Re: Excavation of Ditch Material

J.H. Baxter & Co. Arlington, Washington facility

AOC Docket No. RCRA-10-2001-0086

To: dms461@ecy.wa.gov
cc: macdonald.jennifer@epa.gov, Jan Palumbo/R10/USEPA/US@EPA
Subject: J.H. Baxter

French Drain and Monitoring Location Map

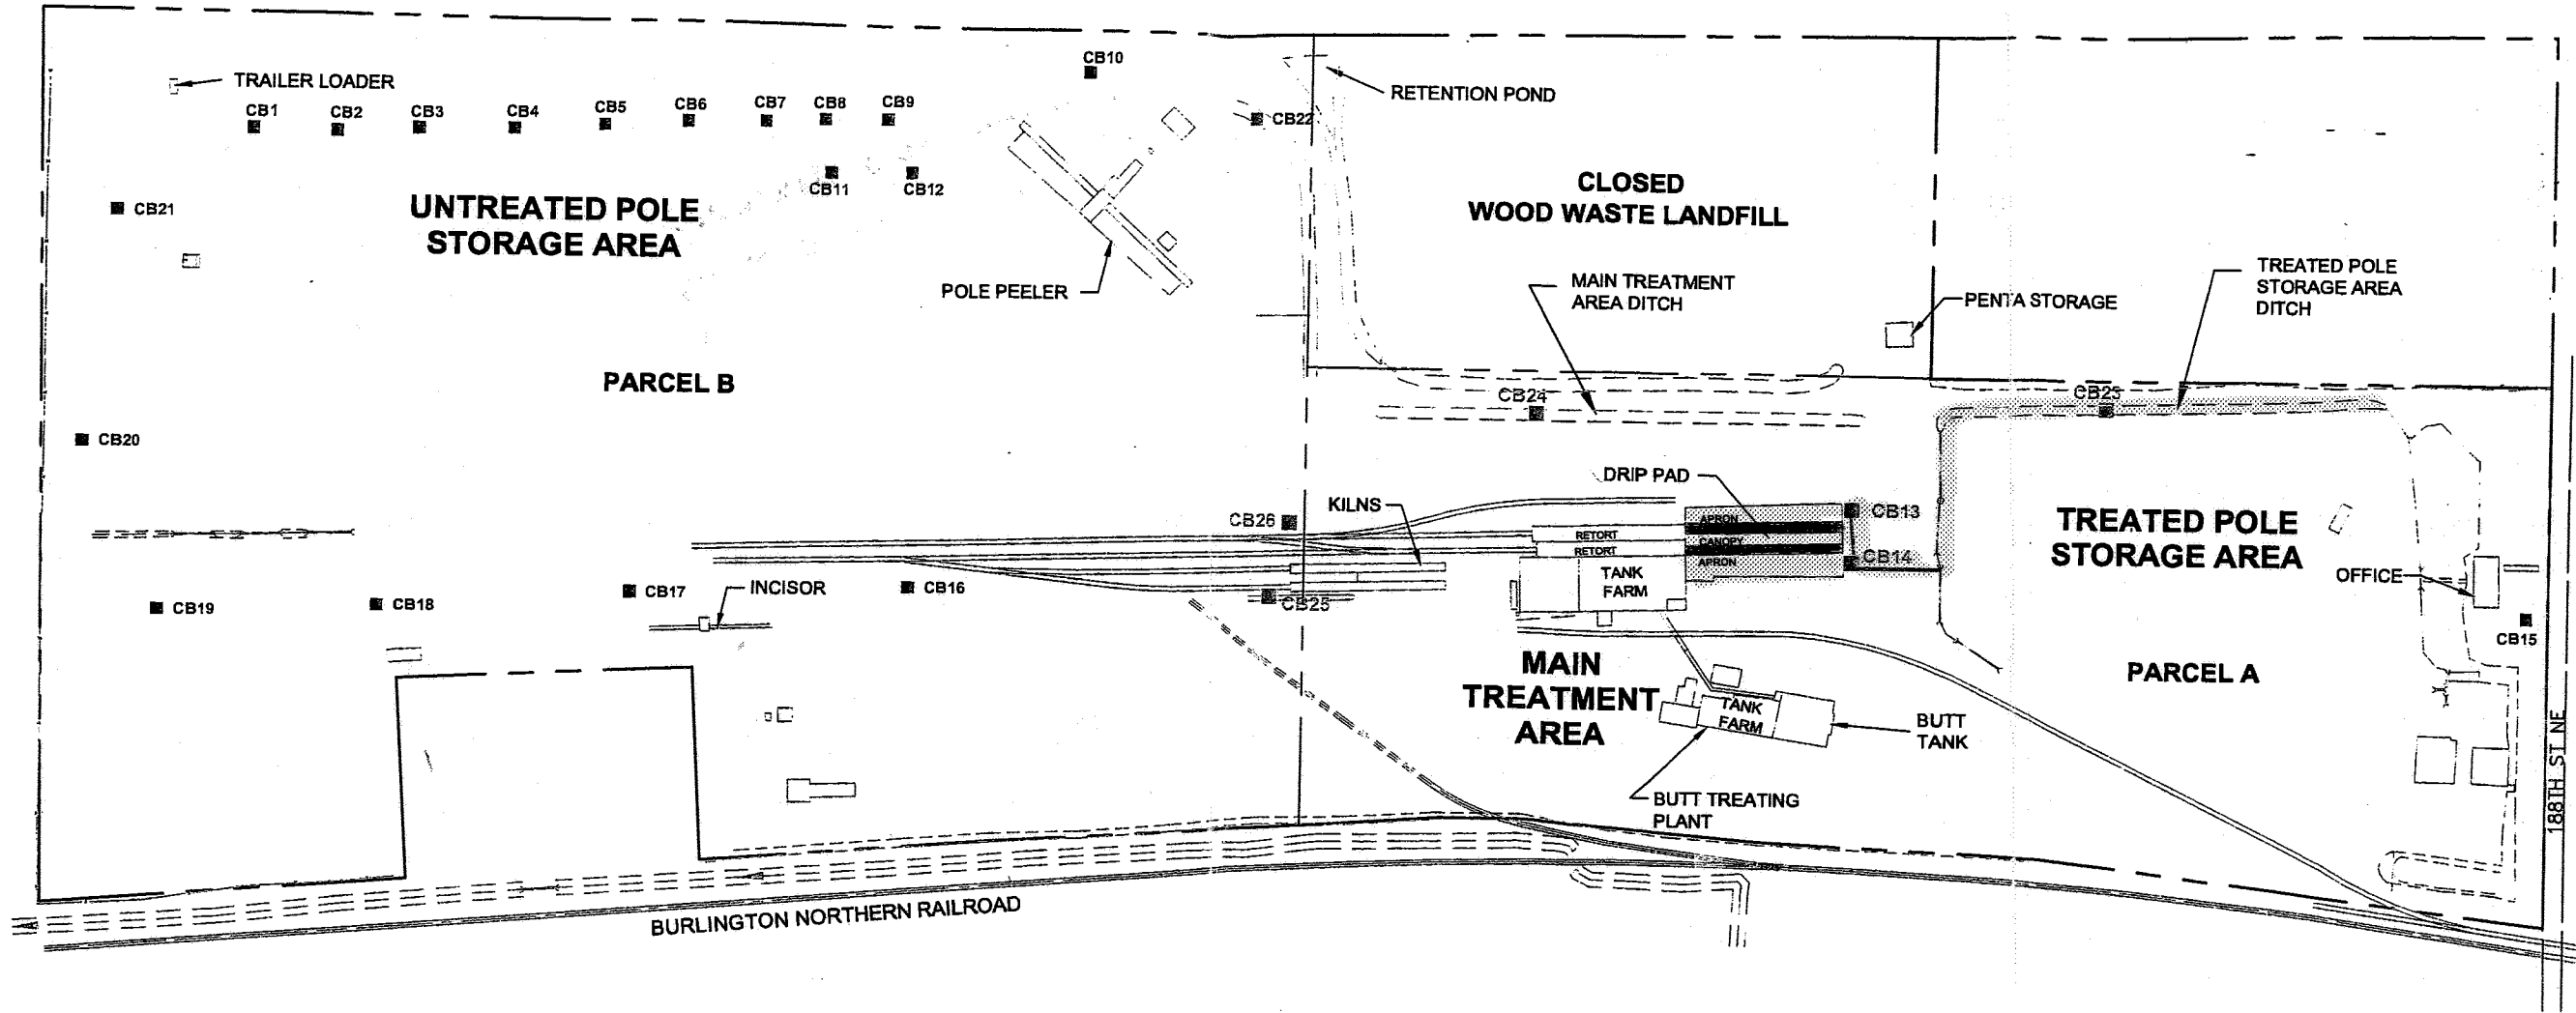
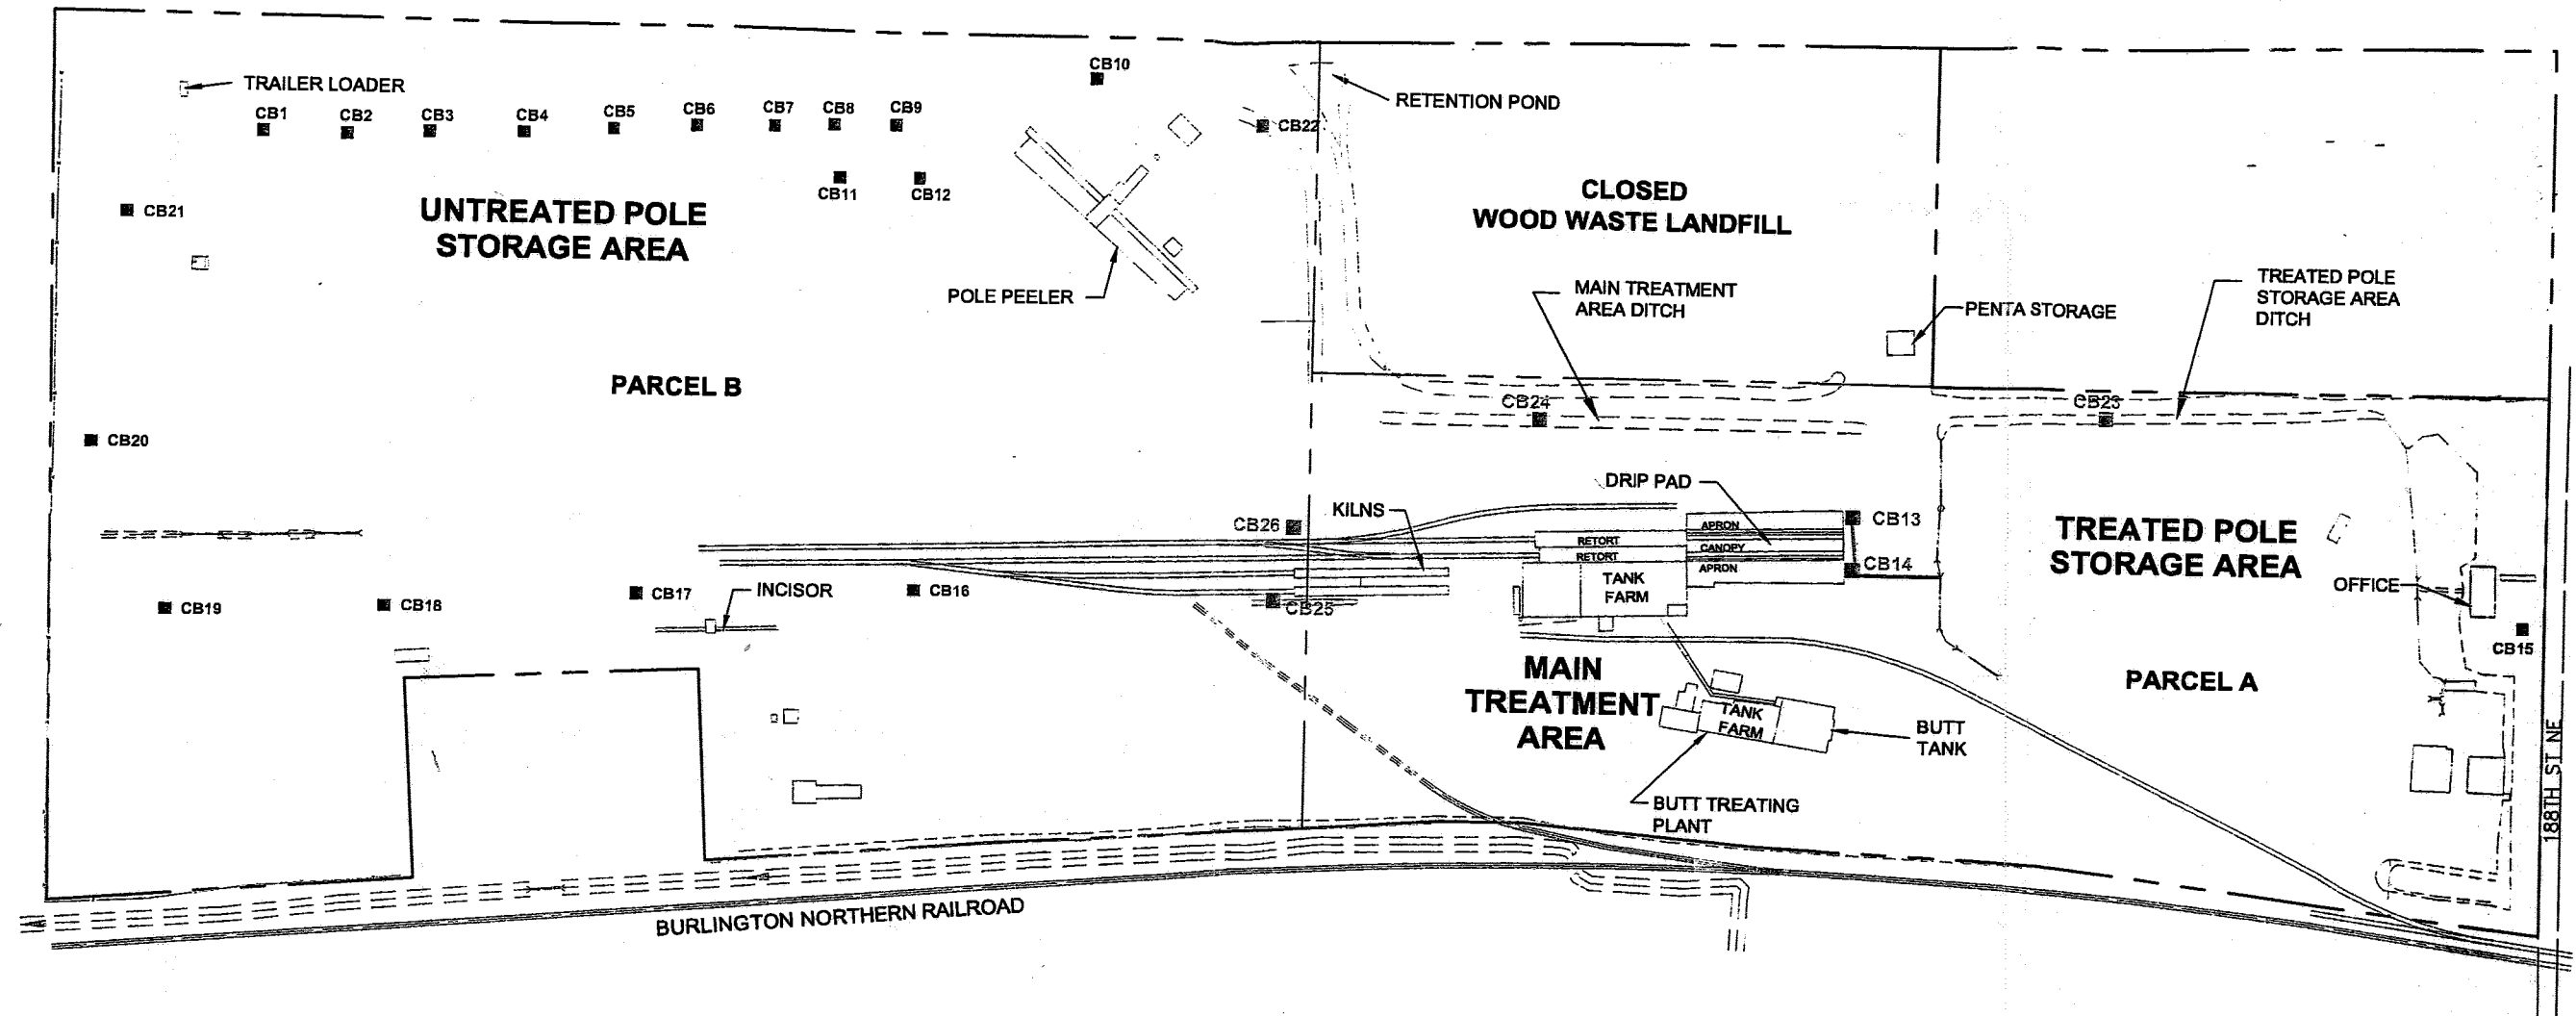
*RCRA units subject to closure
due to disposal of HW w/o permit
or I.S.*

*(2 aprons, asphalt under canopy.
Catch basins 13+14 hand piped to
ditch that contains CB 22)*
